Access Compliance Report

Public Rights-of-Way

| Intersection ID: 10034961 | Main Street: PROVIDENCE_RD_WEST | Cross Street: N/A | Location: SW |
| ADA ID: 8A54203E2761 | Ramp Type: PerpDiag | Initial Pass/Fail: Fail | Overall Compliance: No |

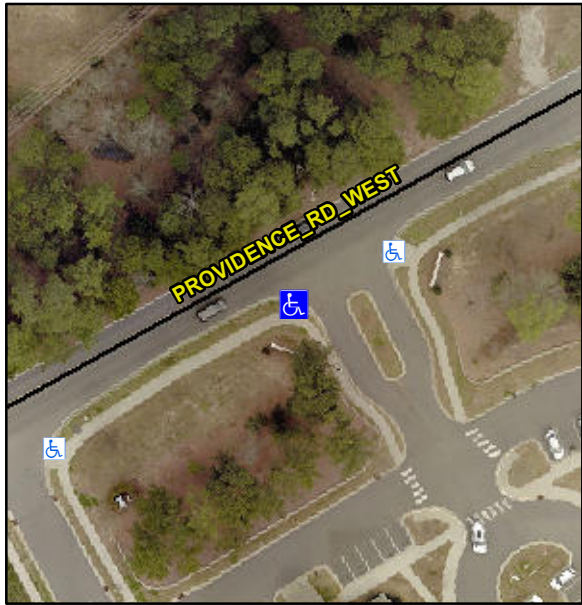
| | PROW/ADA: | | R304.5.1, R304.2.2 | | | |

| Compliance | Description | Data | Compliance | Description | Data |
|------------|-----------------------|-------|------------|-----------------------------|------|
| N/A | Ramp Length (in) | 53.0 | No | Ramp Slope (%) | 9.7 |
| No | Ramp Width (in) | 47.0 | Yes | Ramp XSlope (%) | 0.1 |

|  | Possible Solutions: | | Remove & Replace Curb Ramp With Two New Directional Ramps or Equivalent. | | | |
